Mr and Mrs Taylor

East Yorkshire Solar Farm Nationally Significant Infrastructure
Project

Registration Comments

March 2024

FIGURE TITLE
 Indicative Site Layout
 Sheet 4 of 7

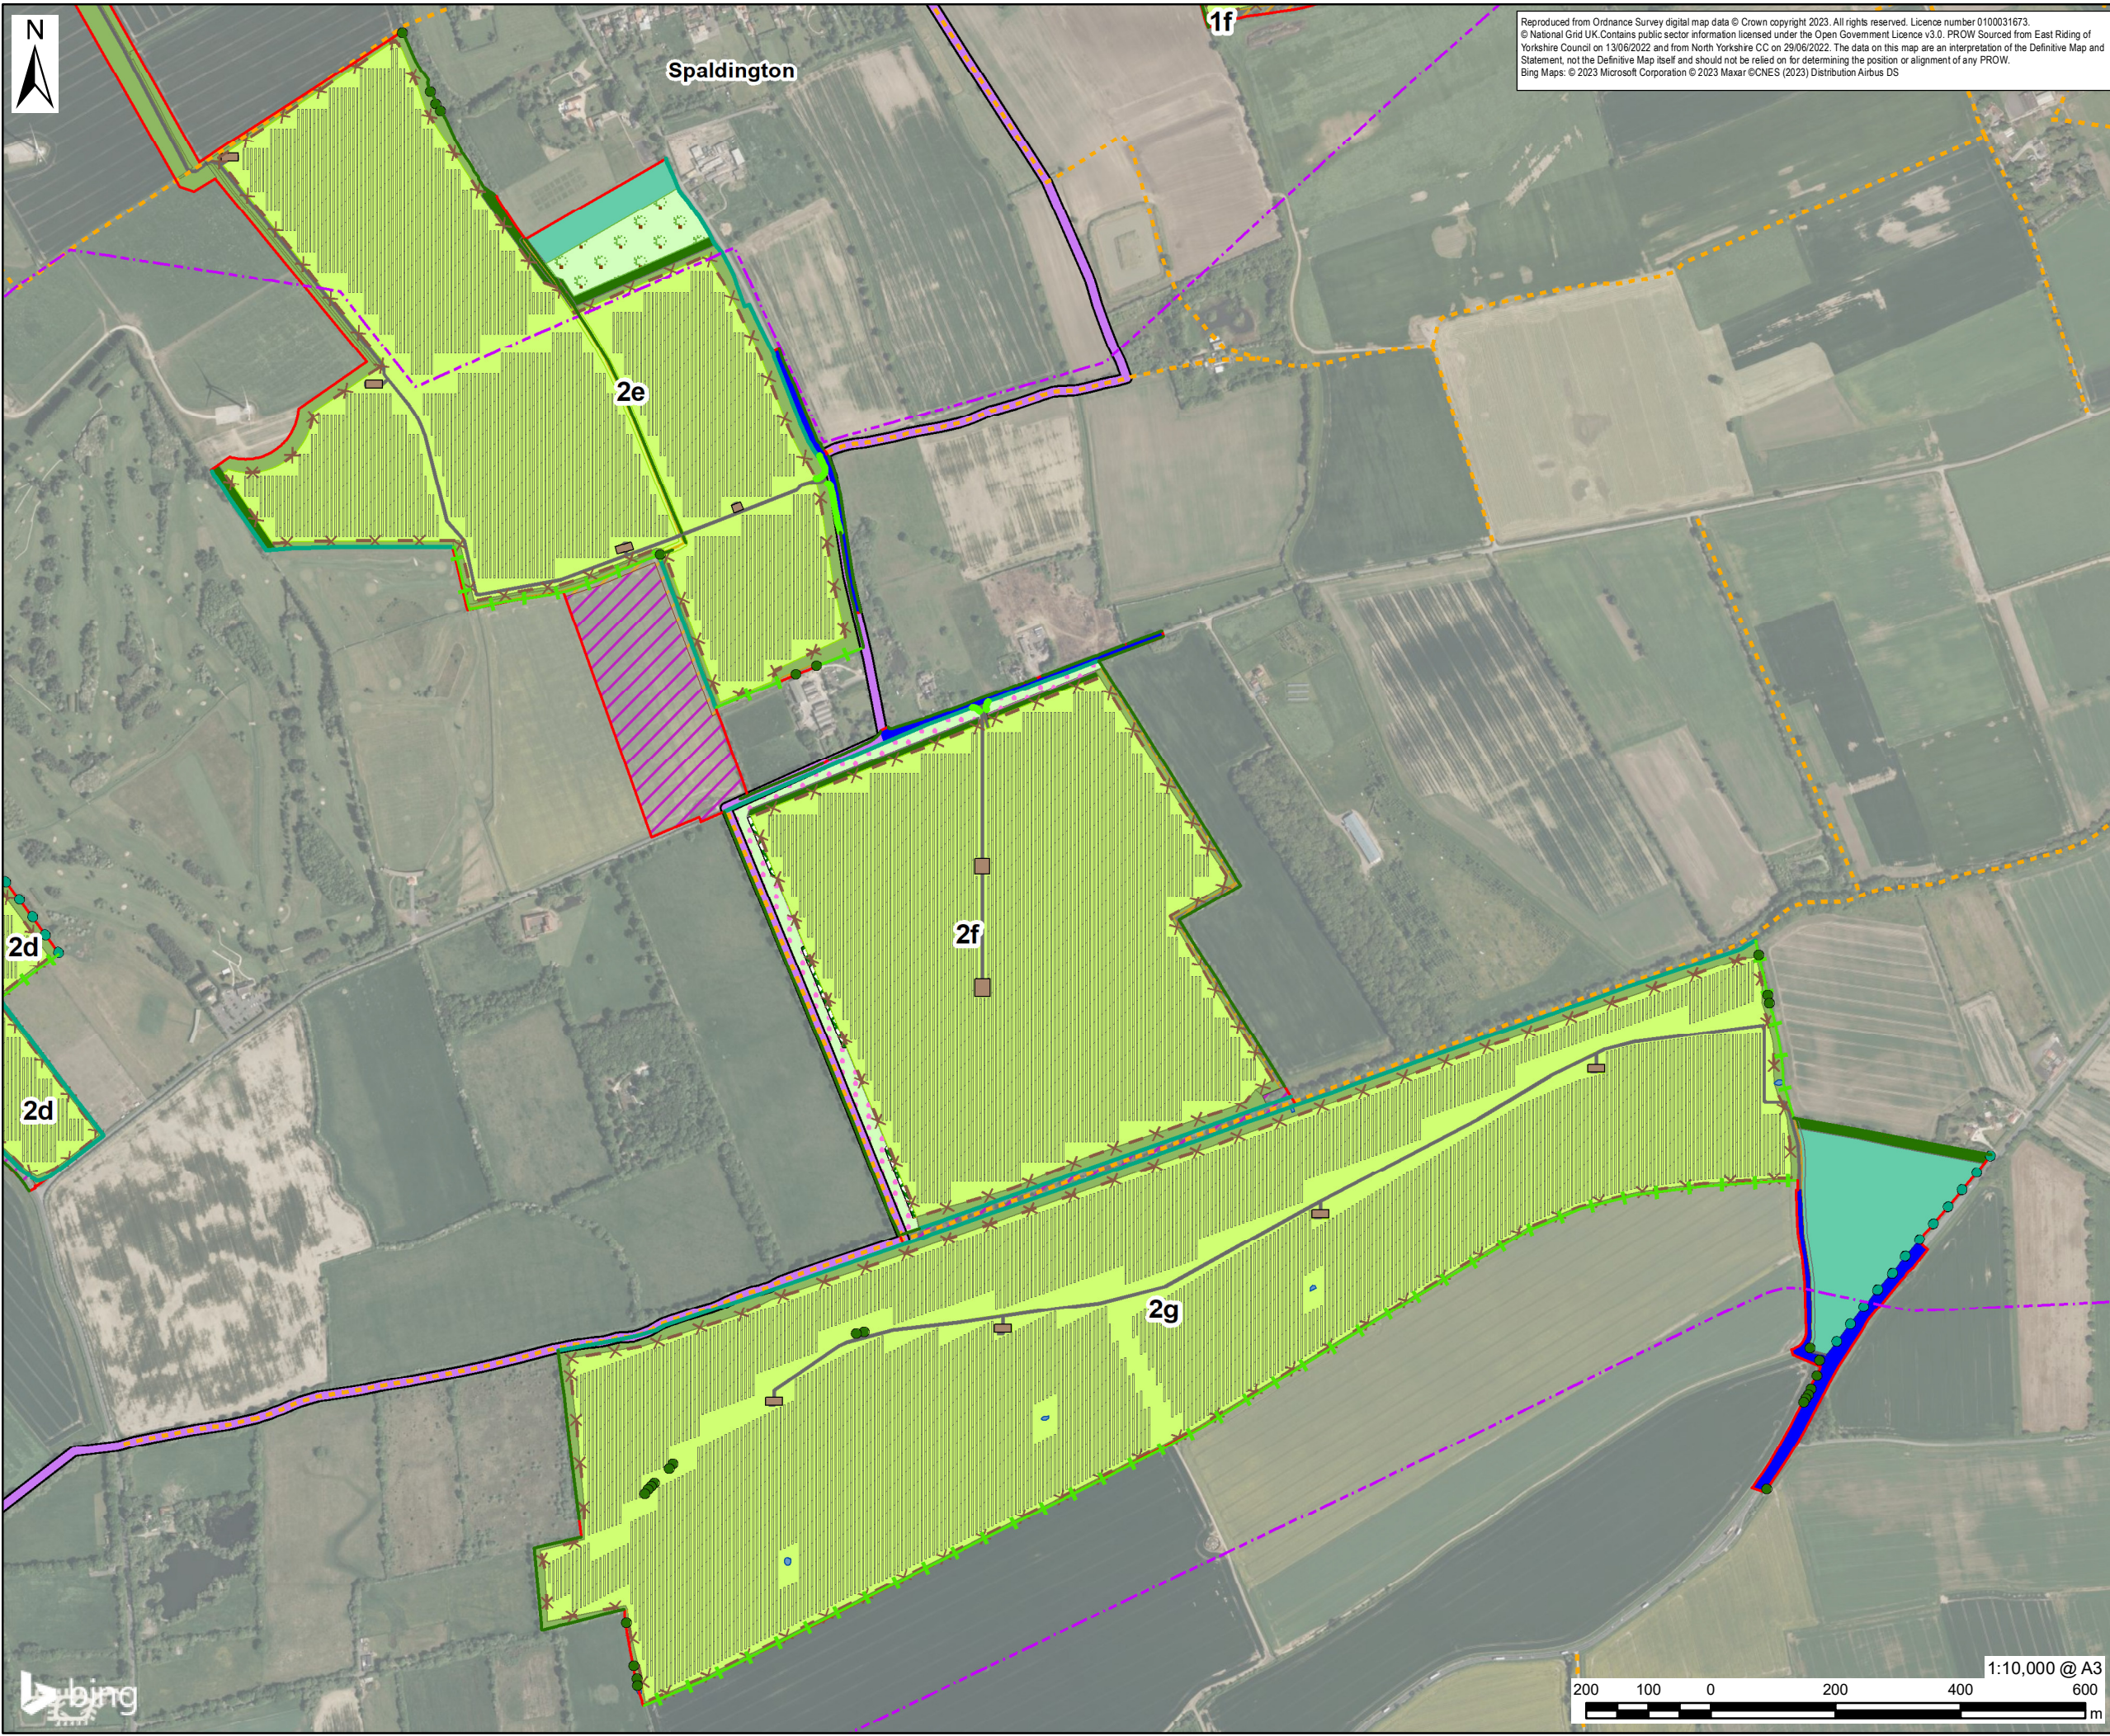
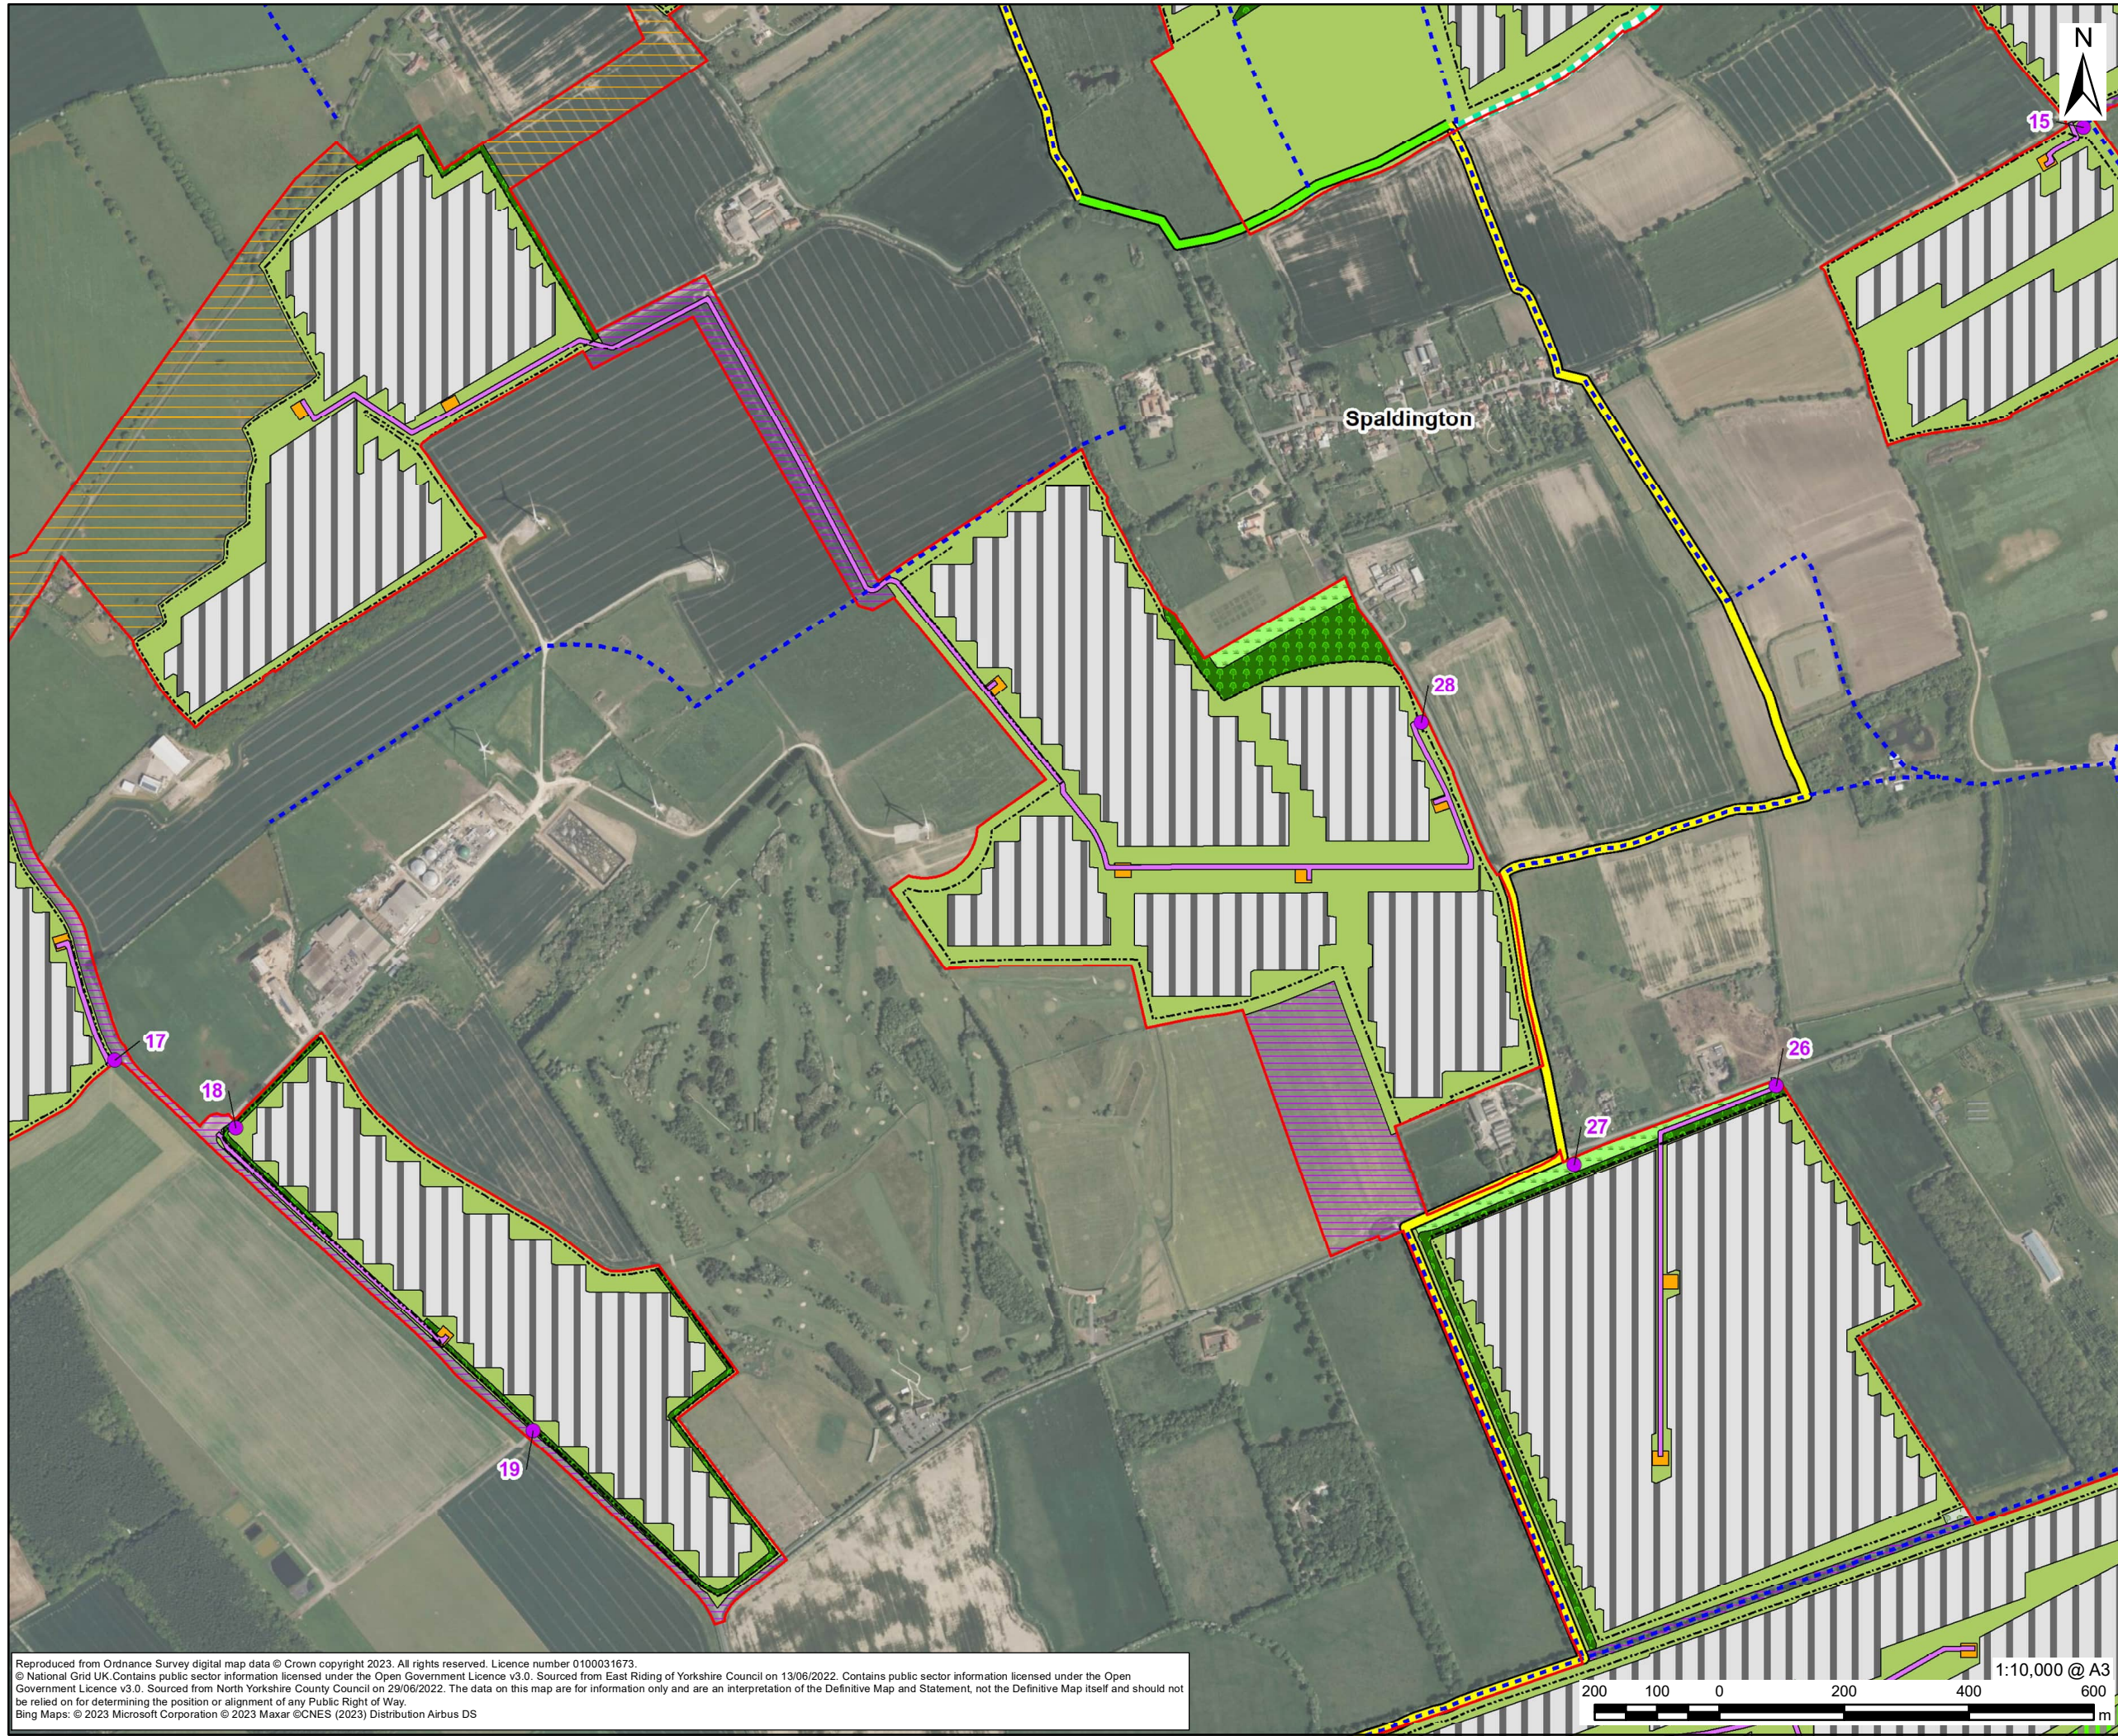
- 2.4. Contrary to this guidance it appears that the applicant has not addressed site-specific issues in relation to our client's property, nor indeed wider issues in relation to impacts on landscape and public rights of way. This is noted from a comparison of the early engagement illustrative plans and the submitted proposal (see **Appendix 1** of this representation). Despite our client writing to the applicant on numerous occasions to raise their concerns, the layout surrounding our client's property has not changed substantially. The same planting scheme appears to have been retained at the north of area 2f and the volume of panels increased in area 2e.

Number/Figure GLY0042 LV01	Project East Yorkshire Solar Farm
Scale 1:10,000 @ A3	Drawing Title View Location Plan
Date 05/03/2024	Client Mr & Mrs Taylor
Checked APF

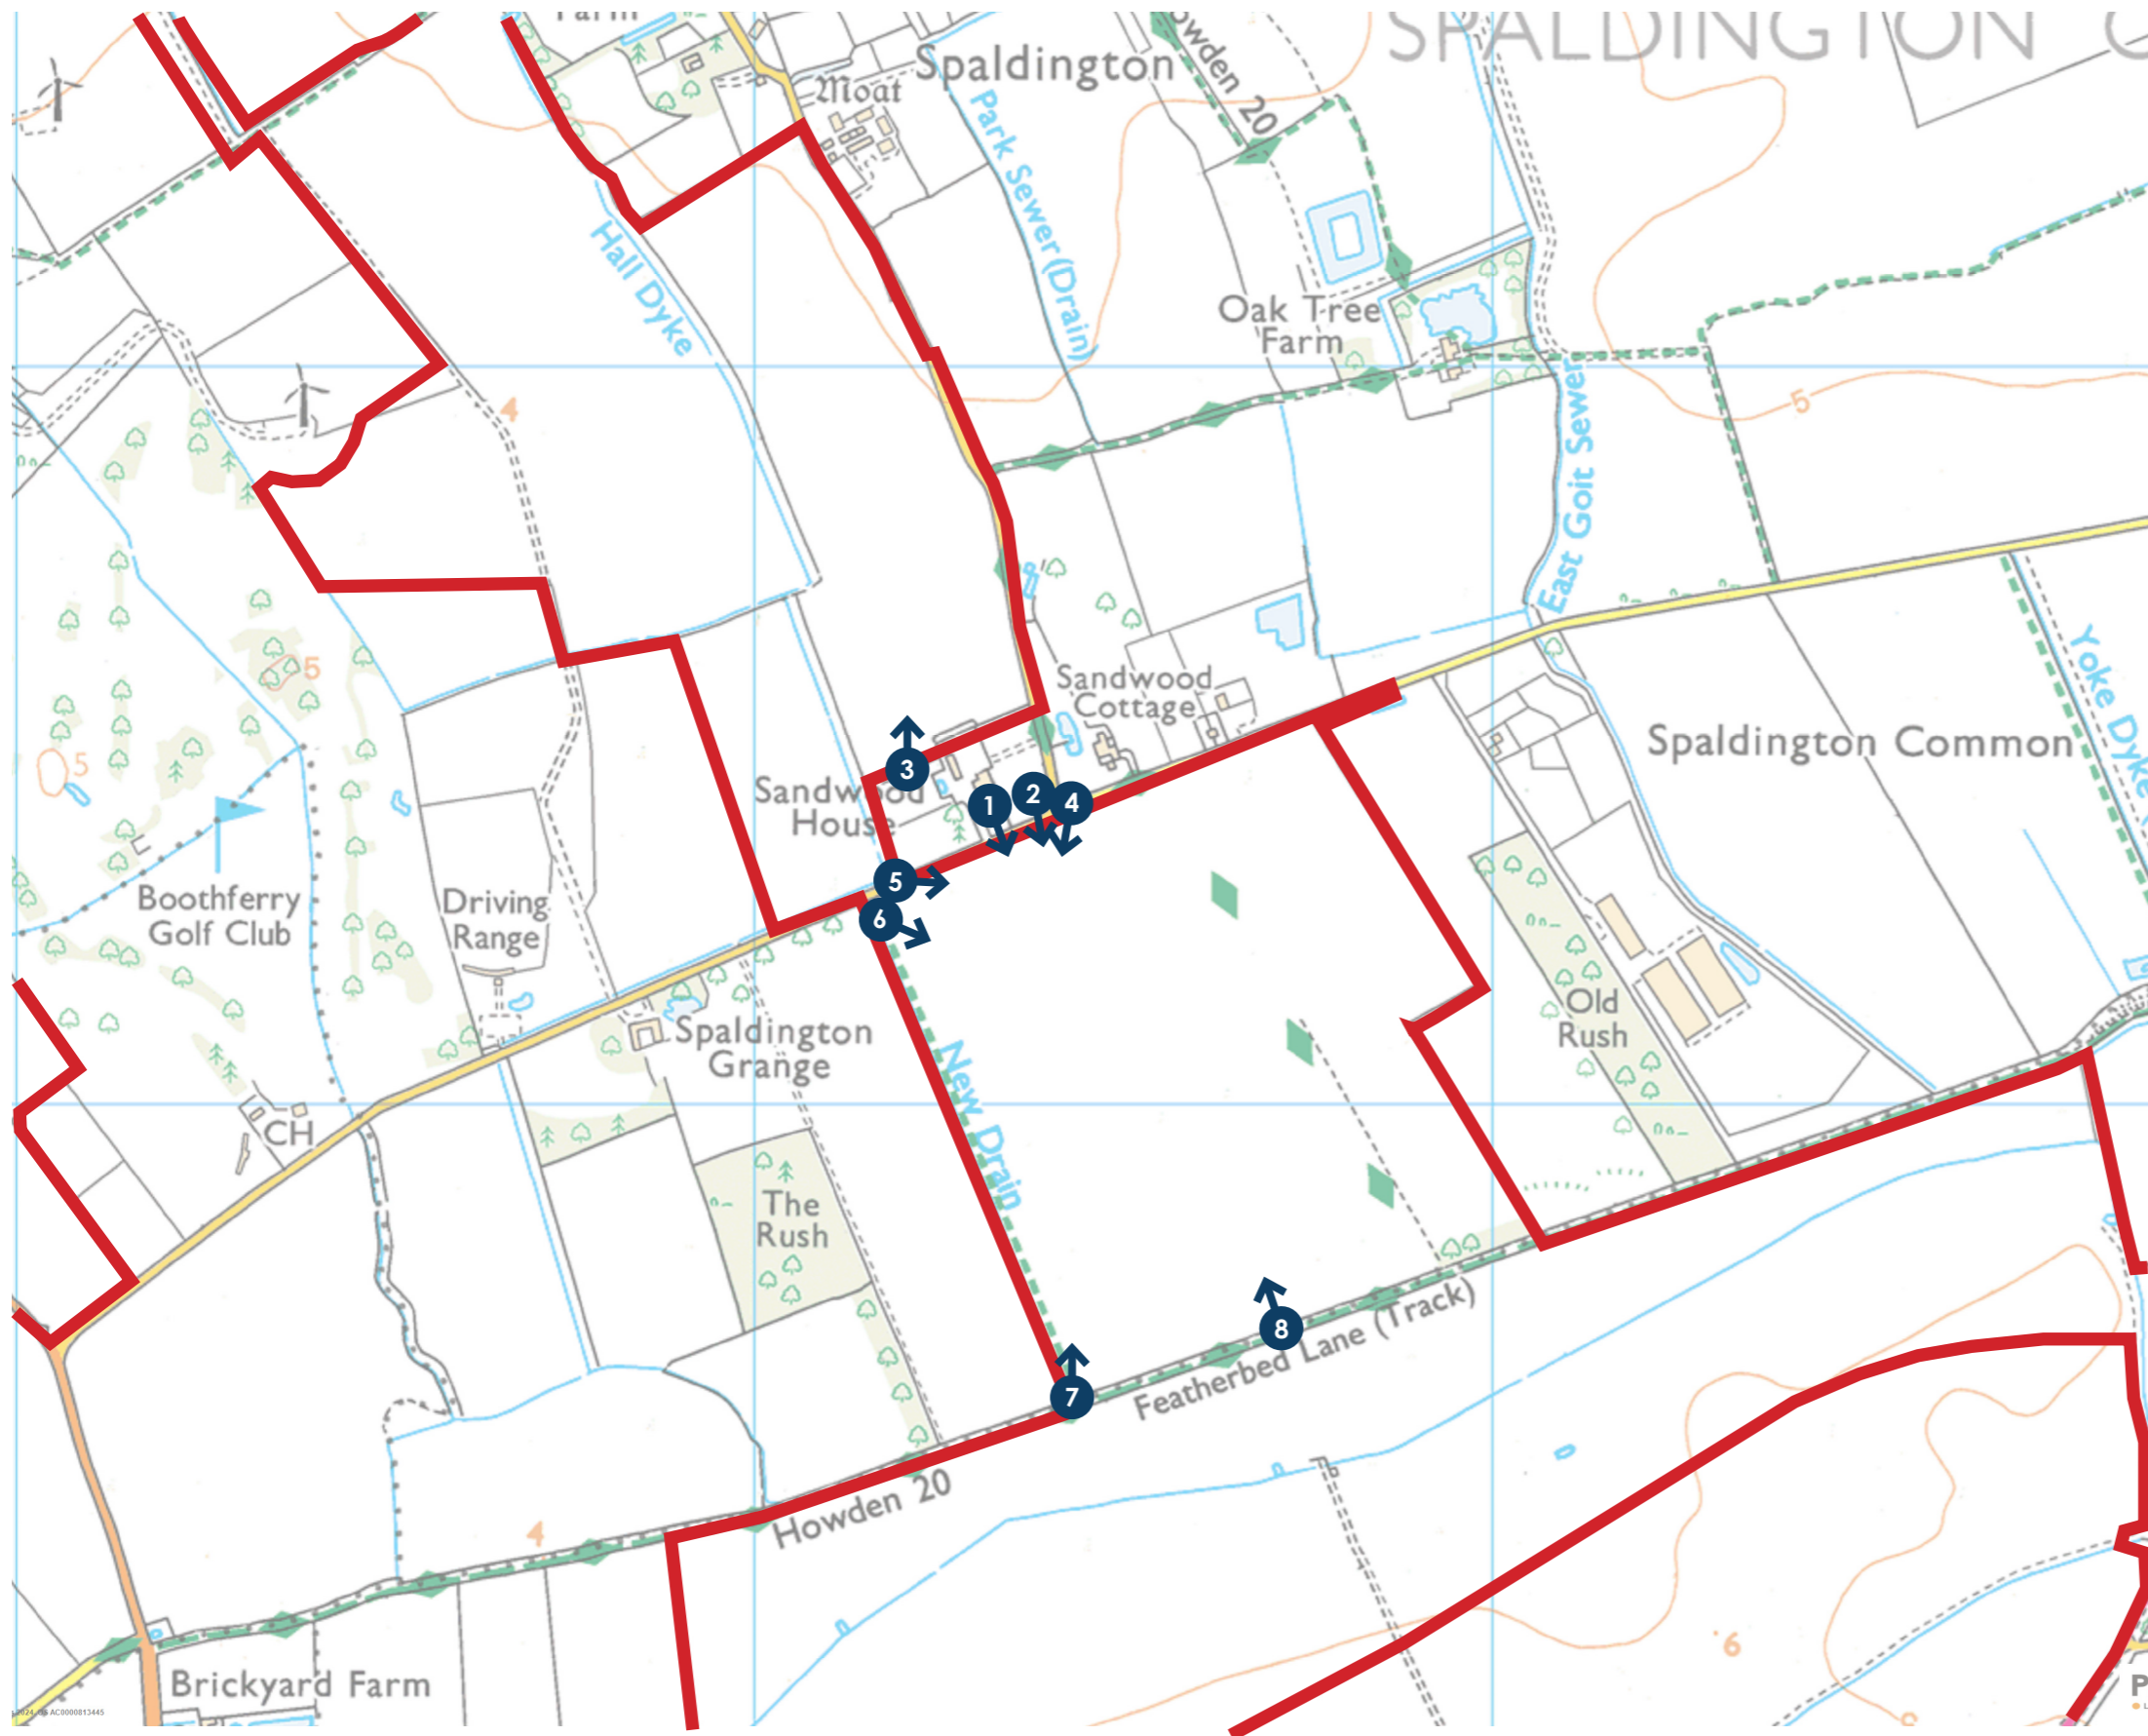
- 3.5. The local setting near to Sandwood House has a positive landscape character evident in its openness and distant views over large fields (see **Appendix 2** of this Statement); surviving semi-natural and natural features including mature woodland, hedgerow and trees; cultural value associated with traditional rural development dating to the late 18th century (Sandwood House & Spaldington Grange), frequent drains and dykes associated with the historic agricultural development, and historic lanes surviving as rights of way (Featheredbed Lane); together with recreational value associated with local Public Rights of Way (“**PRoW**”) and the promoted Howden20 walking route.
